November 6, 2008

**RE: PLUS review – 2008-09-13; Village Brooke East**

**DEVELOPER RESPONSE**

Figure 1: NRCS soil survey update mapping in the immediate vicinity of Village Brook East

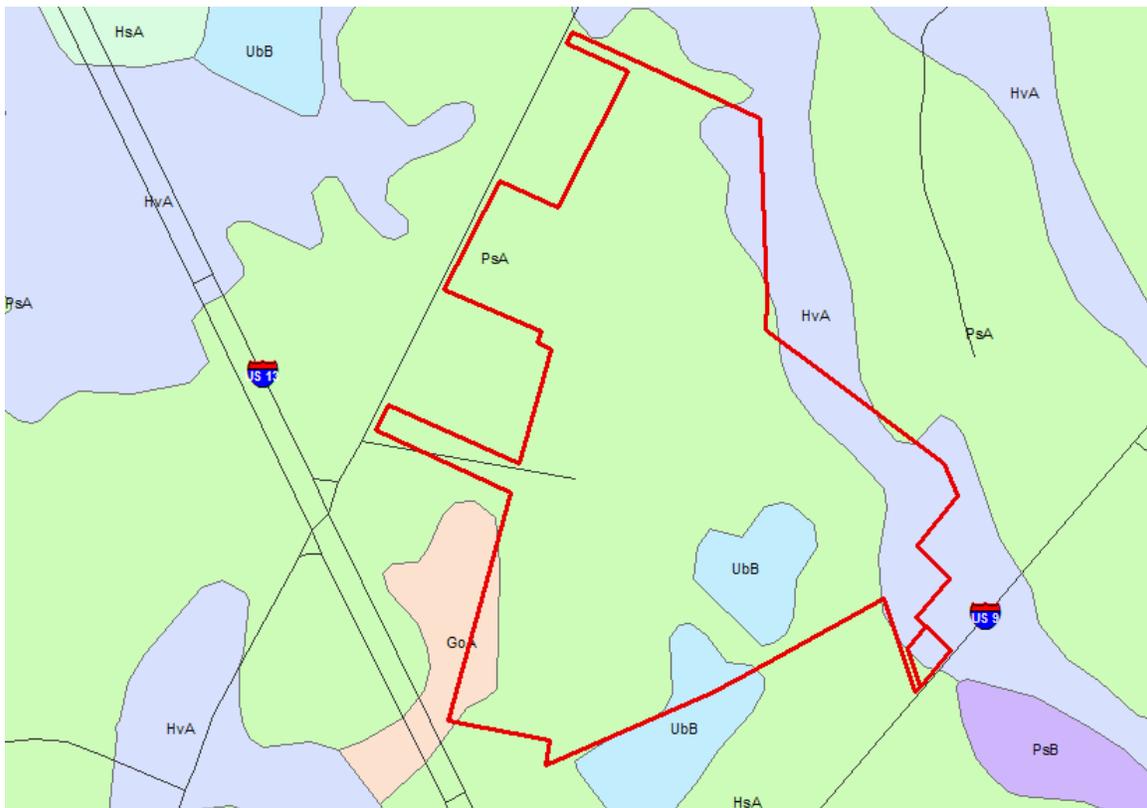
According to the NRCS soil survey update, Pepperbox-Rosedale complex (PsA), Glassboro (GoA), Udorthents (UdB), and Hurlock (HvA) were mapped in the immediate vicinity of the proposed construction (See figure 1). Pepperbox-Rosedale complex is a moderately well-drained to well-drained upland soil that has moderate to few limitations. Glassboro is a somewhat poorly-drained transitional soil (i.e., upland/wetland interface) likely to have both wetland and upland soil components. Udorthents are soils with variable site-specific limitations which have been extensively modified through excavation, filling or grading activities. Hurlock is a poorly-drained wetland associated (hydric) soil that has severe limitations for development. Approximately 10% of the soils mapped on subject parcel(s) lands were mapped as Hurlock. Hurlock soils, as mentioned previously, have severe limitations for development and should not be developed. **The Hurlock soils are generally associated with the mapped wetlands on the site which have not been proposed for development.**

Figure 2: SWMP mapping in the immediate vicinity of Village Brooke East

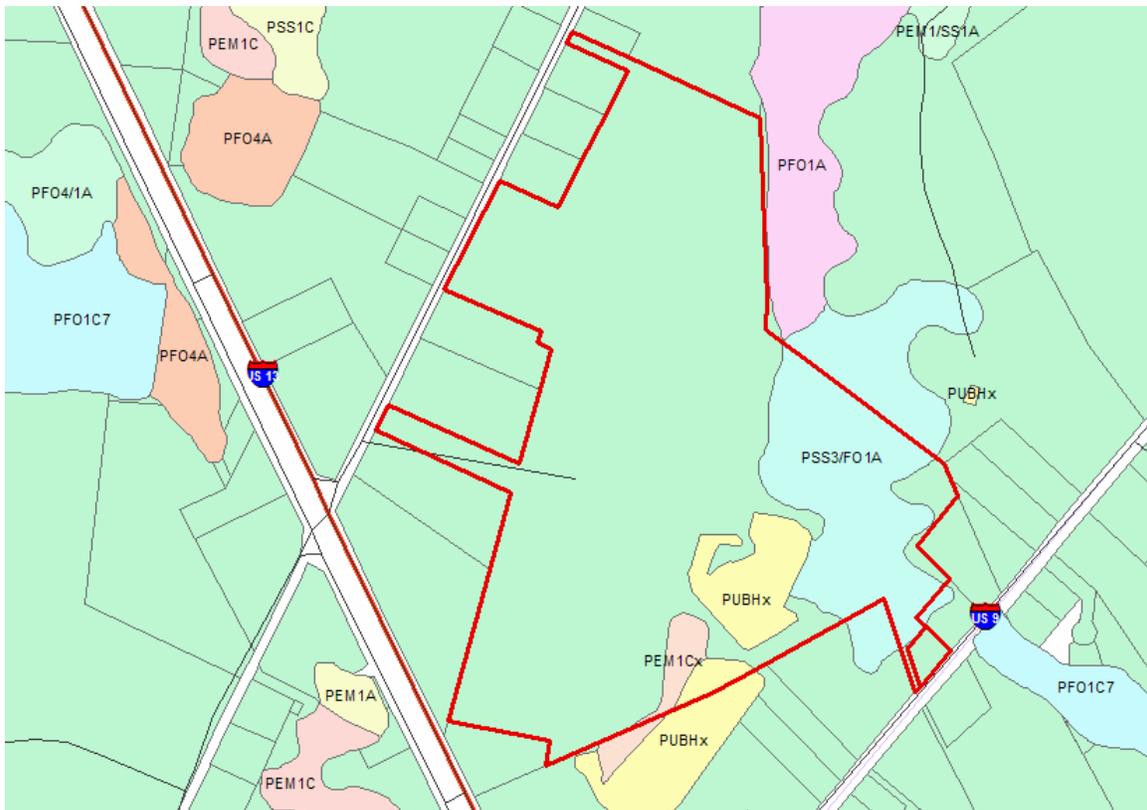
Based on Statewide Wetlands Mapping Project (SWMP) mapping, palustrine forested scrub-shrub forested (PSS3/F01A), palustrine forested (PF01A), Palustrine emergent (PEM1Cx), and Palustrine unconsolidated bottom (PUBHx; an excavated pond) wetlands were mapped in the immediate vicinity of the proposed construction (See figure 2). The developer has retained JCM Environmental to field delineate the Federal jurisdictional wetlands on the site. The field delineation was surveyed by the project land surveyor and illustrated upon a Wetland Boundary Survey and upon the Preliminary Site Plan. All Federal jurisdictional wetlands identified have been avoided on the land use plan and not proposed for any form of development or disturbance.
